Case No. PU-14-842 Dakota Access Pipeline Project PU-742-16 Keitu Engineers & Consultants, Inc.

Site/Project Location: MP 118.5 Spread 9, M.P. 1.5 & 42 Spread 8 Date of Inspection: 29 September 2016

Pipeline ROW going through tree/shrubs near Arnegard and Dunn Center in McKenzie and Dunn County.

Report Photo #3 "Tree Clearing at M.P. 1.5 Spread 8":

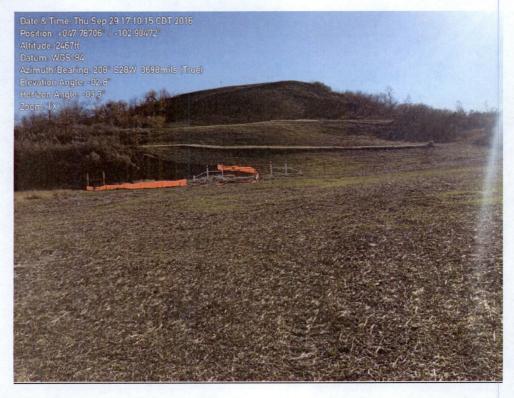
As noted on September 1, 2016, tree/shrub removal extended significantly beyond 85 feet approved at M.P. 1.5 Spread 8. Shrubs were observed and documented on the ROW edges. Further investigating should occur whether these tree/shrubs were surveyed. Shrubs outside the permanent ROW may be mitigated by natural regeneration if: shrubs are cut flush the surface of the ground and if the native topsoil is preserved, but that was not the observed condition i.e. shrubs cleared at M.P. 1.5 on Spread 8 were not cut flush with the ground

Further investigation should occur to see if approved May 2016 reroutes were surveyed for trees/shrubs.
